**RESPONSE MATRIX TO RTS 1 COMMENTS**

Proposed Data Centre – SSD 10101987

707-769 Mamre Road, Kemps Creek (Lots X &amp; Y, DP 421633 and Lot 22 DP 258414)

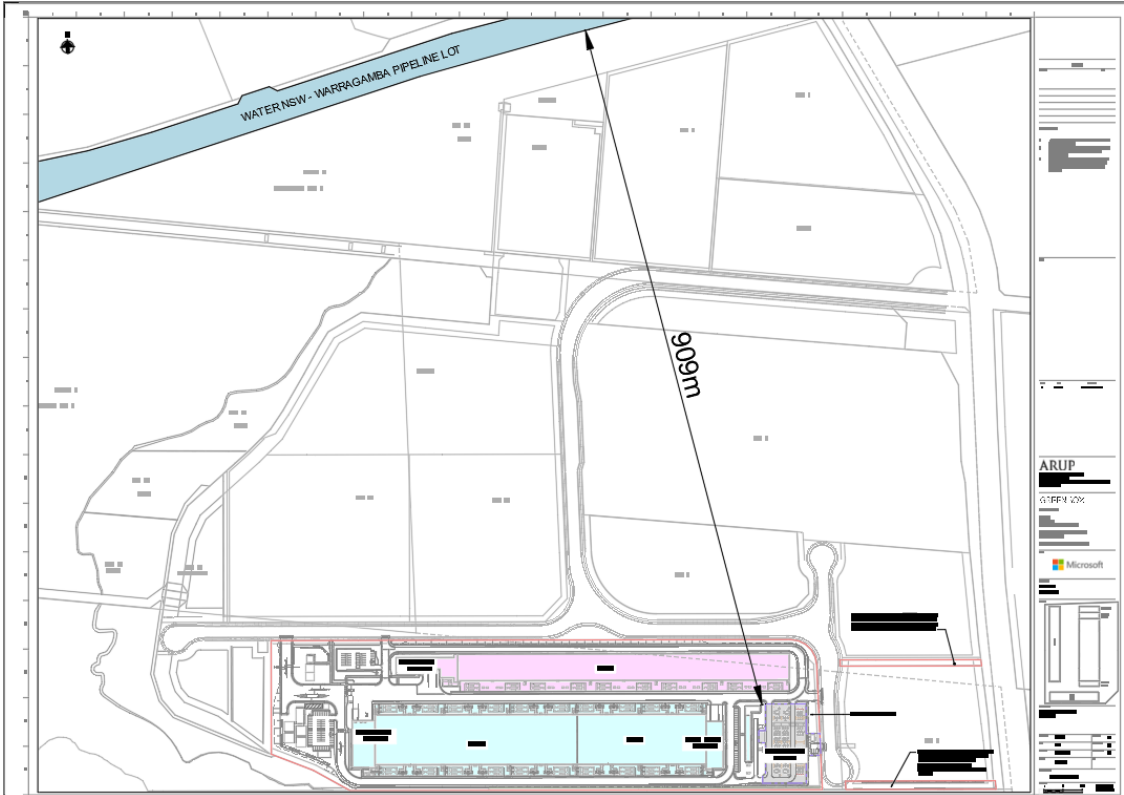
<b>Table 1. Comments on RTS 1 submission</b>	
<b>Query</b>	<b>Comments</b>
<b>Fire and Rescue NSW (FRNSW) – letter dated 18 October 2022</b>	
<p><b>No further comments</b></p> <p>FRNSW note tabled responses at pages 23 - 26 of the Submissions report along with point 19 'Hazards and Risks' in Appendix B, when implemented, would satisfy the recommendations made by FRNSW in our previous letter out concerning this matter dated 15 December 2021 (D21/134018).</p> <p>FRNSW therefore submit no further comments or recommendations for consideration, nor any requirements beyond that specified by applicable legislation at this stage.</p>	<p>Noted.</p>
<b>Water NSW – letter dated 24 October 2022</b>	
<p><b>Electrical hazards on metallic pipelines</b></p> <p>The RtS has not addressed WaterNSW's request for further justification to support their 'no impact' assessment comment, or how their assessment addresses requirements within AS/NZS 4853:2012 Electrical hazards on metallic pipelines. The substation and back-up generators are within the 1km buffer determined by WaterNSW as having a potential impact on our pipeline infrastructure. This is a safety concern.</p>	<p>See below mark-up of plan depicting buffer distance to the substation. We anticipate absolute minimal risk given that the location of the substation and back-up generators are over 900 meters from the closest point of the metallic pipelines.</p>
